Re: Kohler Golf Course NOI

On behalf of Kohler Company, Excel Engineering is submitting the following responses and/or additional information you requested in your April 5, 2018 email. An updated set of digital plans are included with this transmittal and our responses are provided in the order presented in your email as follows.

STORMWATER MANAGEMENT & EROSION CONTROL PLAN

KOHLER COMPANY PROPOSED GOLF COURSE CITY OF SHEBOYGAN, WI

ACCESS ROAD & CART PATH DETAILS

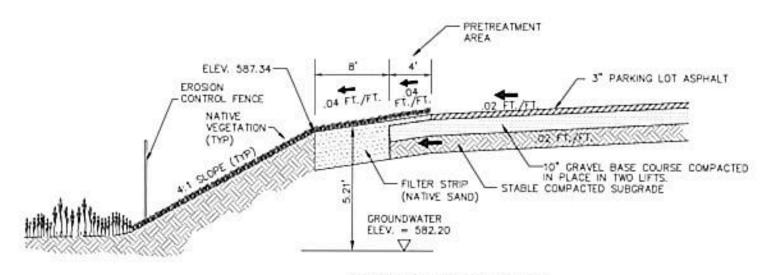
- The infiltration practices, including pretreatment areas and filter strips alter from one side of the cart path to the other, but the detail of the path shows it pitched to one side and not crowned. Is the cart path going to change its pitch depending on which side the filter strip will be located along it? If not, please explain how the filter strips will be effective. - Yes, the cart paths are designed to pitch from one side to the other to a filter strip and not be crowned.
